Safety Evaluation Report

related to the operation of
Catawba Nuclear Station,
Units 1 and 2

Docket Nos. 50-413 and 50-414

Duke Power Company, et al.

Figure 5.1 Feedwater system changes

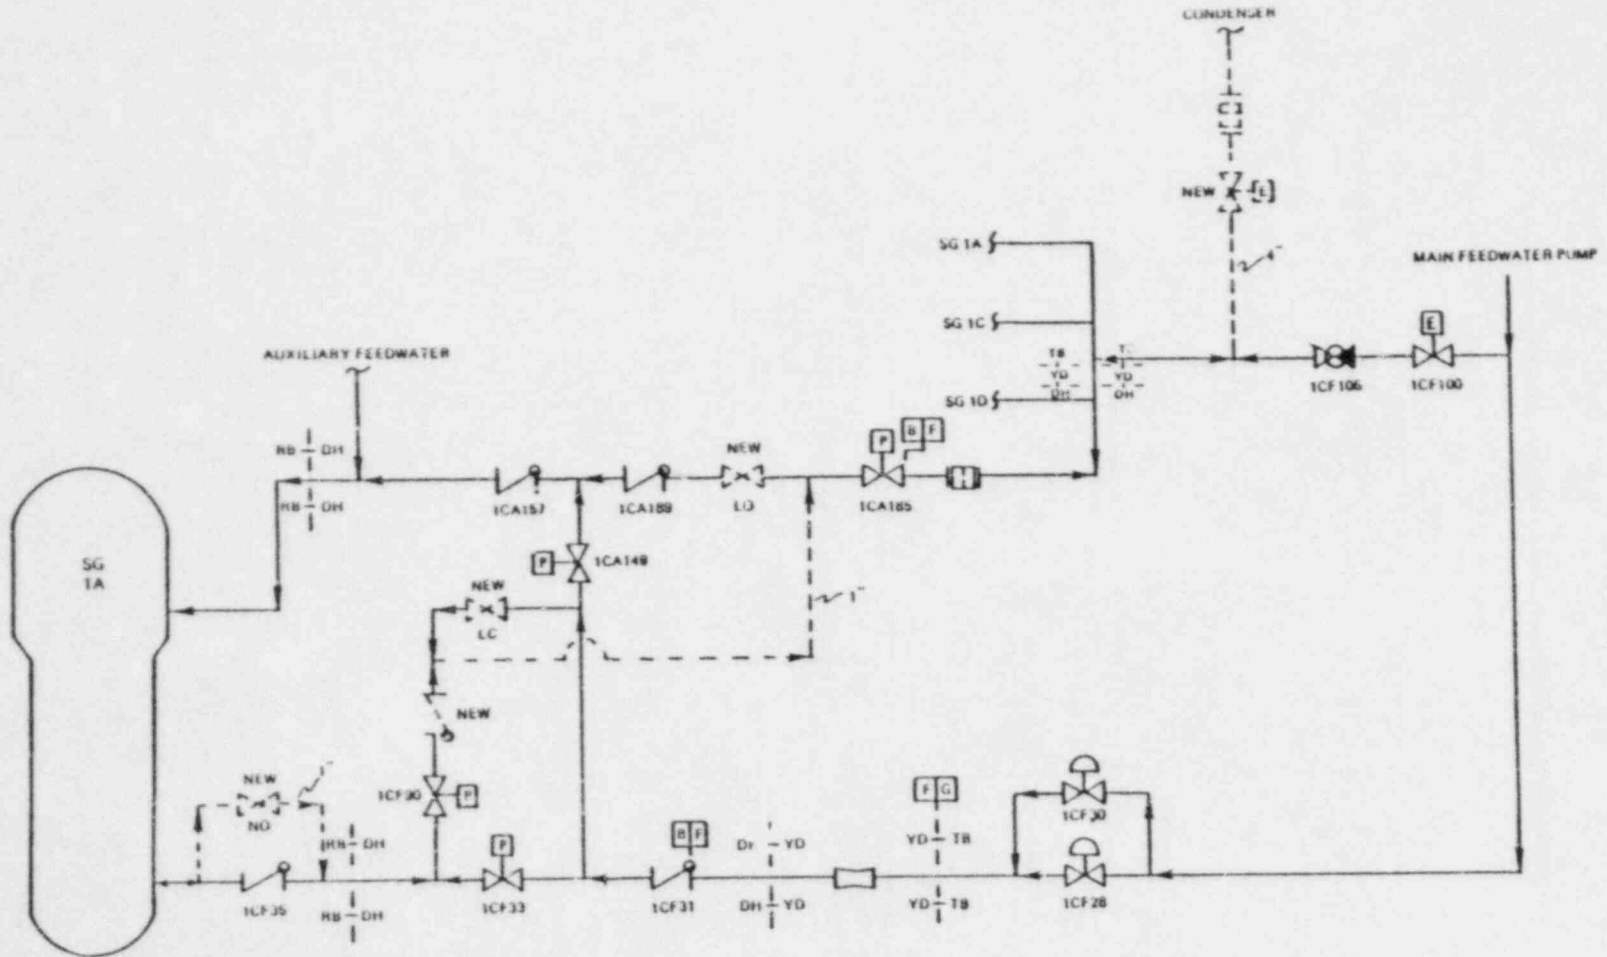
Feedwater system piping changes have been made at Catawba to add additional margin for the forward flushing transient. Instead of using forward purge flow to warm the feedline, hot water from the steam generator will be used. This reverse flushing of the feedline eliminates the thermal transient on the manifold and adds additional margin to the stressed bolts. The staff finds this procedure acceptable and in accordance with the requirements of NUREG-0966.

The piping changes are shown on Figure 5.1 with dashed lines. The applicant has committed to evaluate these modifications in accordance with SRP Section 3.6.2. The staff finds this acceptable.
